RM 15.364

PLANNING EVIDENCE OF RACHEL VAUGHAN

1. My name is Rachel Vaughan. I am an independent planning consultant engaged by Clutha District Council, hereafter the Applicant or CDC, to give planning evidence on a resource consent application for Waihola wastewater treatment plant .

WAIHOLA WASTEWATER TREATMENT PLANT
CONSENT NO: 2002.046 CONDITION 2 (C)
BACKFLOW MINIMISATION REPORT

Fig 2 Daily Flow Record Lake Waihola Treatment Plant

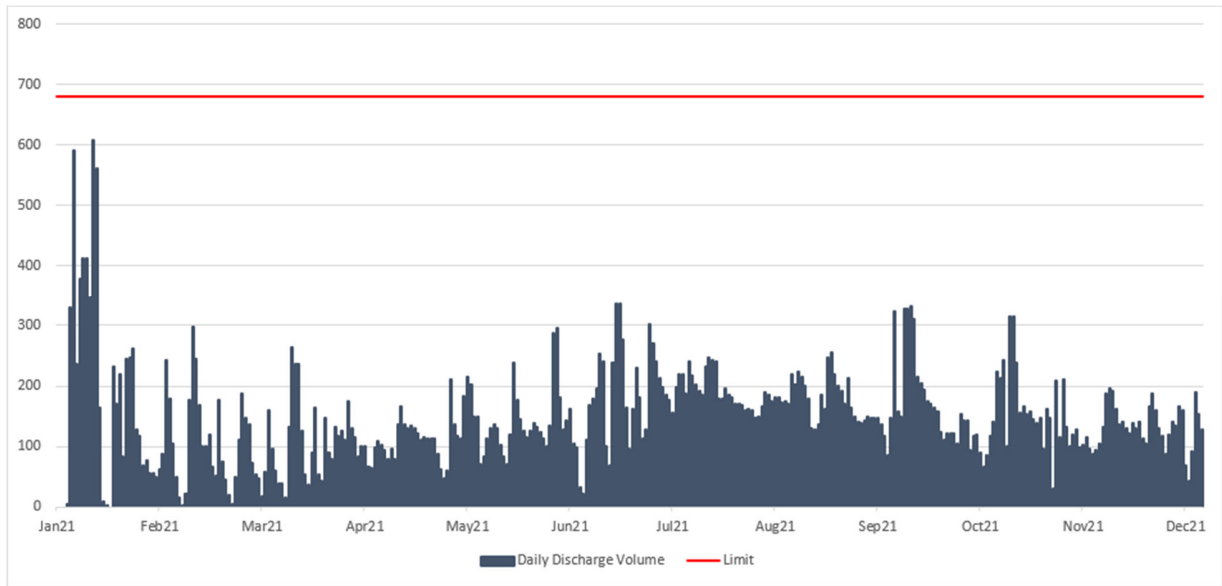
The Clutha District Council cannot agree to this condition.

The discharge shows effects of infiltration and inflow.

The Clutha District Council is giving priority to identifying inflow and infiltration in Waihola.

The Clutha District Council has recently inspected 196 properties connected to the sewer network in Waihola, 46 have been requested to raise gully traps and 7 to remove cross connections. This will assist with lowering the flow of rainwater into the system.
